[Docket No. FAA–2009–1253; Directorate Identifier 2009–NM–080–AD; Amendment 39–16629; AD 2011–06–05]

**Airworthiness Directives; The Boeing Company Model 737–600, –700, –700C, –800, –900, and –900ER Series Airplanes**

**ACTION:** Final rule.

**Figure 1**

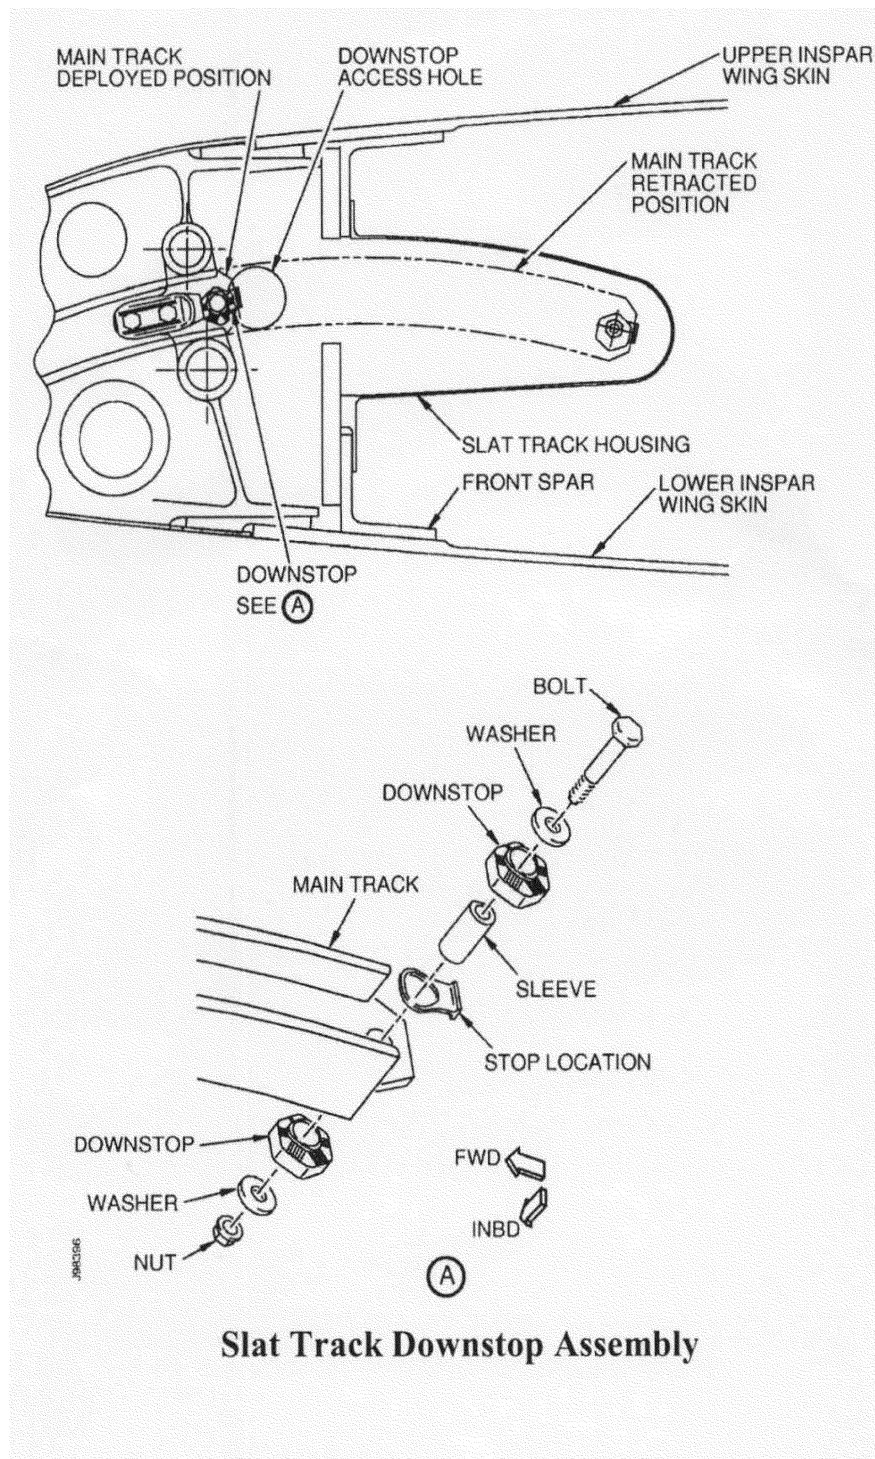
- (g) Within 10 days after September 26, 2007 (the effective date of AD 2007-18-52): Do a detailed inspection or a borescope inspection of each main slat track downstop assembly to verify proper installation of the slat track hardware (*i.e.*, the bolt, washers, downstops, stop location, and nut shown in Figure 1 of Boeing Service Letter 737-SL-57-084-B, dated July 10, 2007, and in this AD). Proper installation of the sleeve need not be confirmed, and the stop location part may be installed on either the inboard or the outboard side of the slat track. If any part is missing or is installed improperly, before further flight, install a new or serviceable part using a method approved in accordance with the procedures specified in paragraph (j) of this AD; and do a detailed inspection of the inside of the slat can for foreign object debris (FOD) and damage. Before further flight, remove any FOD found and repair any damage found using a method approved in accordance with the procedures specified in paragraph (j) of this AD. Verify proper installation; install a new or serviceable part; and inspect for damage and FOD, and remove FOD and repair damage; in accordance with a method by approved by the Manager, Seattle Aircraft Certification Office, FAA; or in accordance with Boeing Multi Operator Message Number 1-523812011-1, issued August 25, 2007, or 1-527463441-1, issued August 28, 2007. Repeat the actions required by paragraph (g) of this AD thereafter at intervals not to exceed 3,000 flight cycles.
